Palo Verde Nuclear
Generating Station

**Subject: Palo Verde Nuclear Generating Station (PVNGS)
Unit 2, Docket No. STN 50-529
Response to Request for Additional Information Regarding
Steam Generator Replacement and Power Uprate License
Amendment Request**

**NRC Reactor Systems Branch
Questions and APS Responses**

Figure 28.c-1: CEA Drop DNBR vs. Time

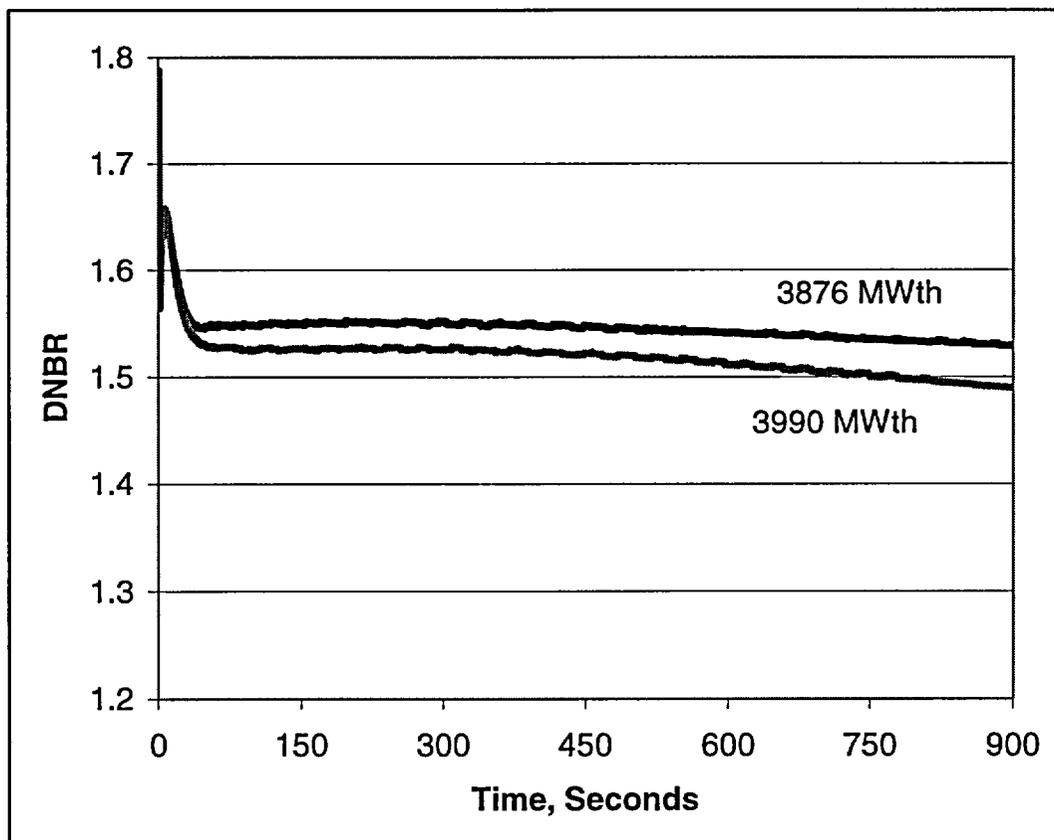
Provide a plot of the acceptance criteria (MDNBR and linear heat generation rate) vs. time for this event.

APS Response:

The requested plots for MDNBR and LHGR are contained in Figures 28.c-1 and 28.c-2.

The responses of the MDNBR and LHGR are shown for 15 minutes following the single CEA drop. After 15 minutes, the operators will act to reduce core power in accordance with Section 3.1.5, "Control Element Assembly (CEA) Alignment," of the COLR to maintain thermal margin.

Figure 6.3-141
Total Loss of RCS Flow-System-Pressure vs. Time

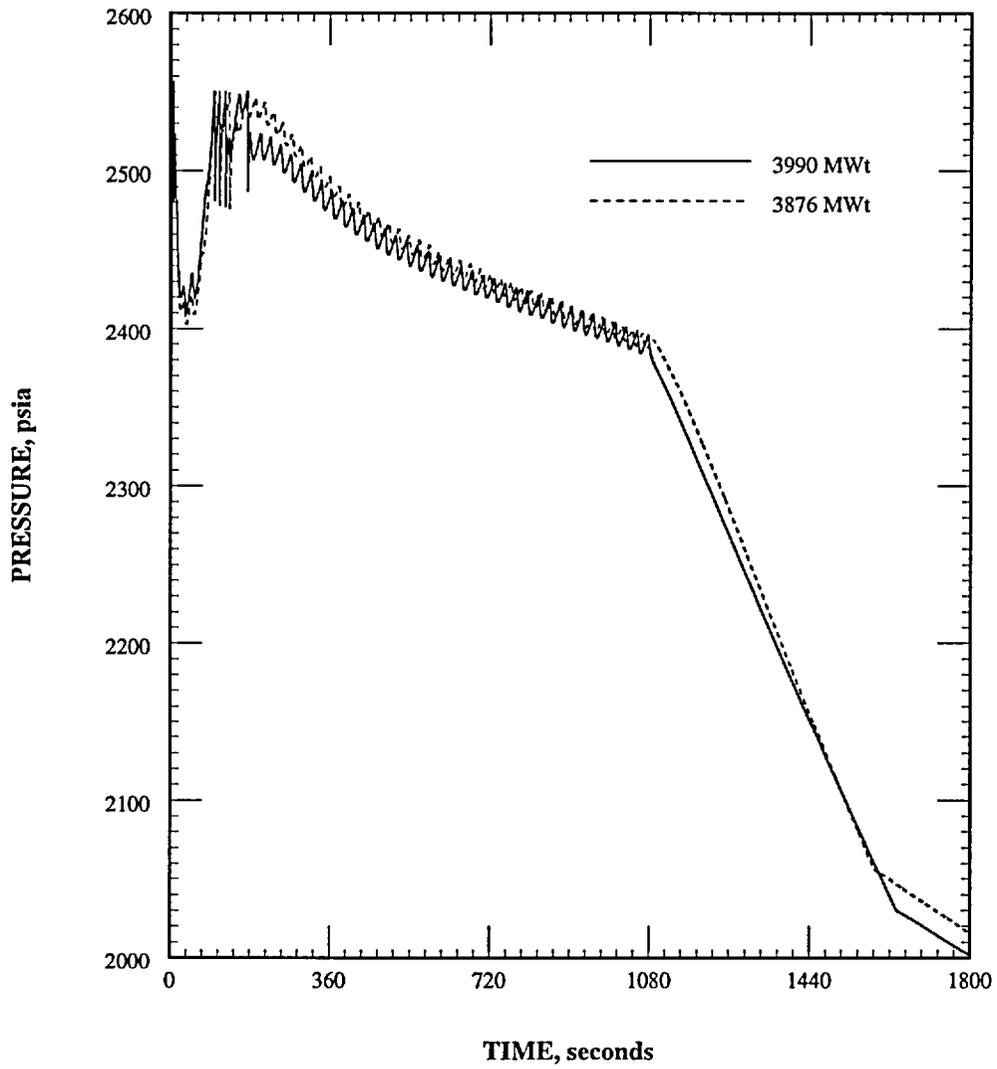
Attachment 6, Section 6.3.3.1.5, Table 6.3-34: At 28.8 sec, the main steam safety valves (MSSVs) begin to cycle. The pressure-time function indicates a wavy pattern as shown in Figure 6.3-141. Discuss, if this is caused by MSSV cycling, is it not likely that the MSSVs will fail. Unlike the Power operated relief valves, the MSSVs are not designed for prolonged cycling.

The wavy pattern in secondary and primary pressures in the Figures 6.3-141 and 6.3-145 are due to the opening and closing of the first bank (low set pressure) MSSVs during the transient. The question was raised that MSSVs are not designed for prolonged cycling. This is a true statement; in fact, the valves are designed not to cycle rapidly but to actuate (open/close) within their specified nameplate blowdown capacity. This is accomplished through valve design as discussed below.
